Product Change Notification

Change Notification #: 117206 - 00
Change Title: Intel® Server Chassis H2204XXLRE, PCN 117206-00, Product Design, 3.5" Tool-Less Carrier Design Improvement for 2.5" Drive Support
Date of Publication: October 15, 2019

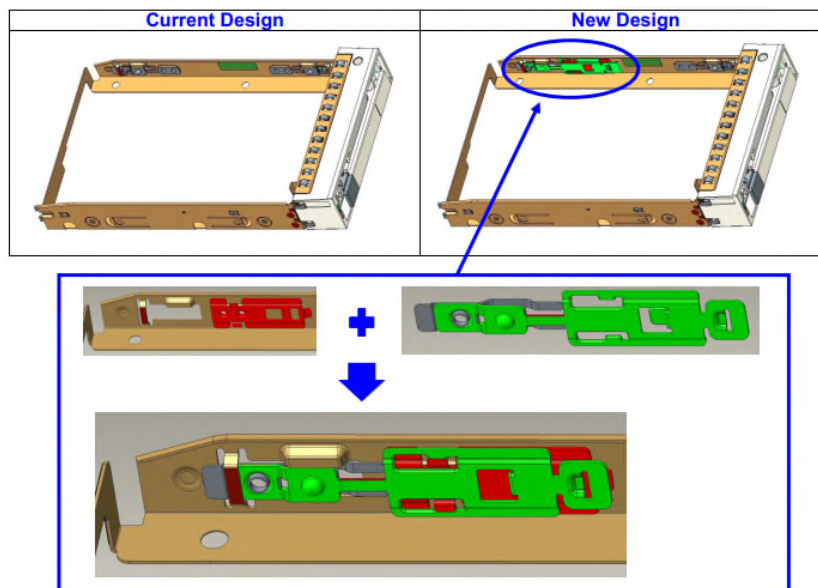
Intel is implementing an improvement on FXX35HSCAR2 3.5" tool-less drive carrier for 2.5" drive support in factory for Intel® server chassis H2204XXLRE

- New rear spring (see image in green) and new spring holder (see image in red) attached to the tool-less drive carrier.
- Removing the rear spring of 3.5" tool-less carrier when Install 2.5" SSD drive, Installing the rear spring to support 3.5" HDD.
